# UNITED STATES PATENT AND TRADEMARK OFFICE

<b>Office Action Summary</b>	<b>Application No.</b> 10/773,160	<b>Applicant(s)</b> COATES, FREDRICA V.	
	<b>Examiner</b> Karin M. Reichle	<b>Art Unit</b> 3761

## **DETAILED ACTION**

**FIG. 9.**

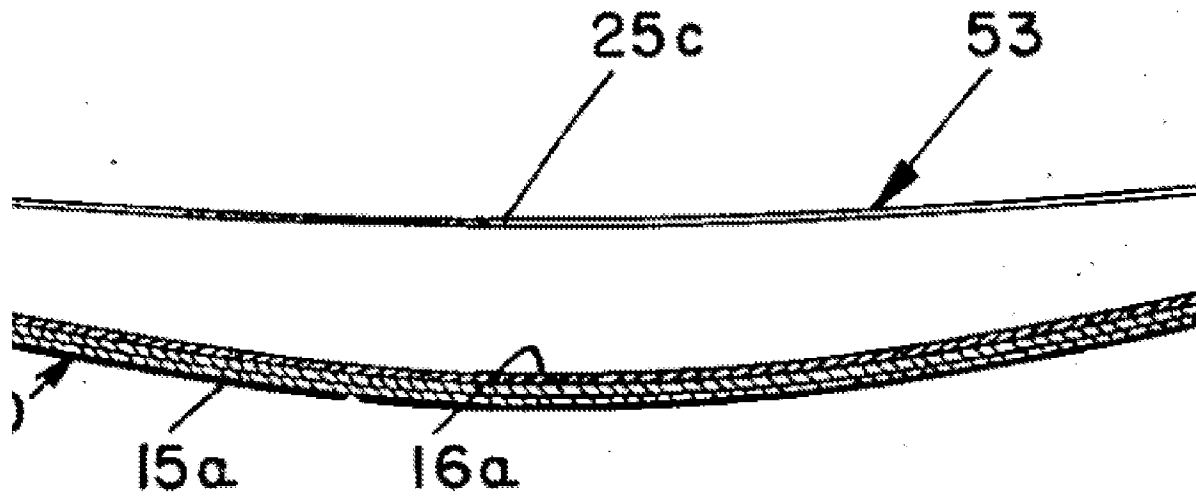
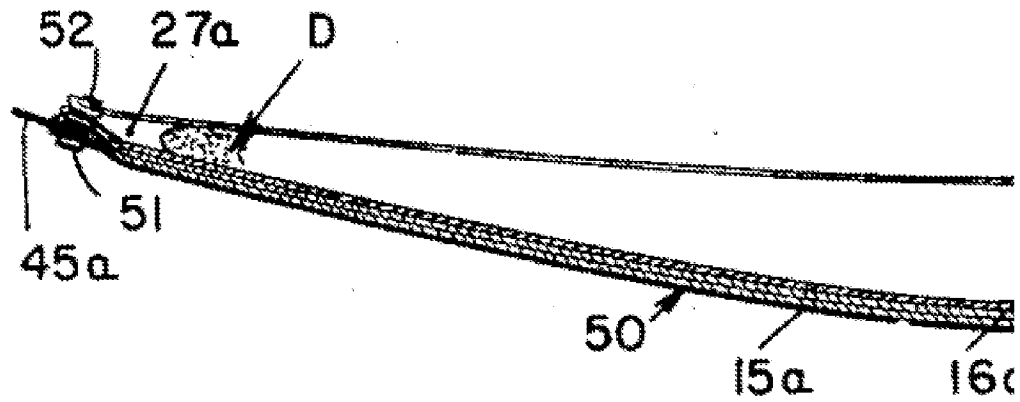
Claims 20 and 21: See Claim Language Interpretation section supra hereinafter also referred to as CLI and Figures 7-9, and note the blow-ups of Figure 9 in Appendix A attached to this action, col. 1, line 55-col. 2, line 6, col. 2, lines 14-31 and col. 3, lines 23-43, i.e. the first

part/outer layer is the outer layer of 15a, the first part/anchor layer is the inner layer of 15a, the stitching is 17. The outer layer and anchor layers are separate fabrics layers, the former shaped to conform to a buttock and leg region of the user, see Figures, and the latter having a shape conforming to that of the former. The second part/pocketed sling is 53 which includes four sides and is detachably coupled to the anchor layer but not directly detachably coupled to the outer layer, i.e. only indirectly so coupled, by releasable fasteners which are snap fasteners of two portions 51, 52 located respectively on the anchor layer and sling, see blow up in Appendix A, col. 2, line 7 and col. 3, line 21, elements 20-21 as shown in Figure 2, col. 3, lines 31 and 36-41 and elements 20a, 21a, 50-51 as seen in Figures 7-9. The sling extends from the anchor layer on the inner side of the undergarment when the undergarment is worn to form a pocket for retaining a fluid absorbent pad, i.e. diaper D, facing inwardly away from the anchor layer. The sling is displaced inwardly from corresponding sides toward the center of the anchor layer and inwardly from the stitches between the anchor layer and the outer layer at, e.g., 7b, 7c, 8b, and 8c. It is noted that the entire periphery/all portions of all four sides of the sling is/are not required to be so inwardly displaced from the entire periphery of the anchor layer. However also note the position of 31 in Figure 3 and the position of 51 and 52 in Figures 7-9 with regard to stitching 17. The outer layer overlies fasteners on the anchor layer, e.g. 20a, 21a, 50 and/or 52. Claim 20 now requires the outer layer completely overlying the releasable fasteners. While the outer layer overlies a portion of the fasteners 51, 20a, 21a which are on the inside thereof and fasteners 52 when the garment is unfastened and overlies completely some fasteners, e.g. 20a, when the garment is fastened, see Figure 1, such layer does not appear to completely overlie the fasteners on the anchor layer. Claim 21 further requires the fasteners be filamentary fasteners while '983

Claim 24: The releasable fasteners 51 on the anchor layer are located only “adjacent”, see CLI, opposite ends of the pocketed sling, i.e. located between but only “adjacent” opposite terminal ends, i.e. both lateral and longitudinal, of the sling layer, see Figures 7-9. It is noted that extent of the ends relative to overall longitudinal and lateral extent of the sling has not been set forth.

Claim 30: The anchor layer is attached to the outer layer around the entire periphery of the anchor layer, i.e. see stitching 17 in Figure 7.
